City of Portland, Maine – Building or Use Permit Application 389 Congress Street, 04101, Tel: (207) 874-8703, FAX: 874-8716

BUILDING PERMIT REPORT

REASON FOR PERMIT: To Construct a single family dwelling/attached garage.

**CITY OF PORTLAND, ME
BOCA 1996 Plan Review Record
One and Two Family Dwelling**

PLOT PLAN
OF:
LOT 9 AUBURN PINES SUBDIVISION
AUBURN PINES DRIVE
PORTLAND, ME
FOR:
NORMAND BERUBE BUILDERS, INC.
1040 U.S. RTE 1
SACO, ME 04072

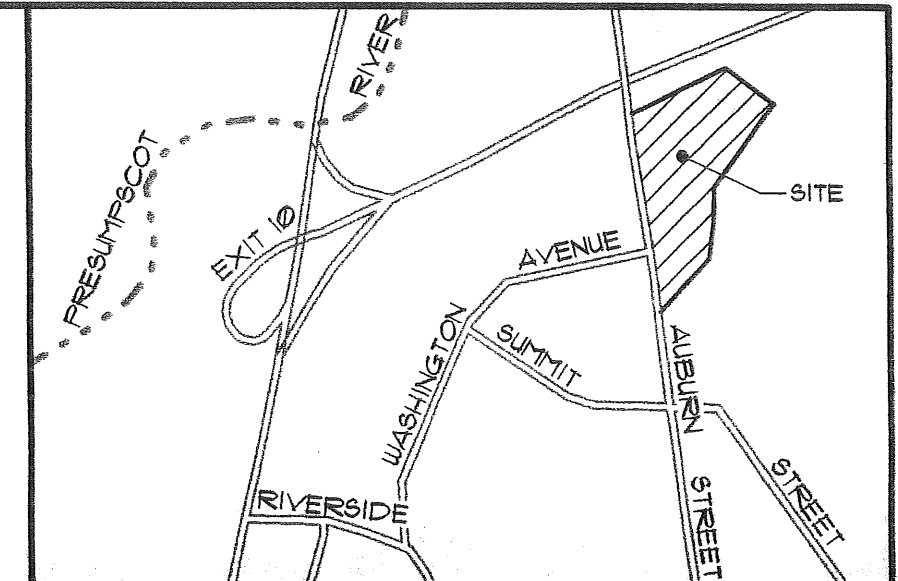
Per sheet C3 of the original subdivision plans, lot 9 was to have been the location of a temporary stock pile. If necessary, the applicant shall relocate any stock piles to an alternative location. The grading plan shall be revised to direct runoff from the disturbed area of the lot towards the street. The applicant shall refer to sheet P1 of the Auburn Pines subdivision plans for the street grades. The applicant shall be responsible to avoid drainage impacts to abutting properties.
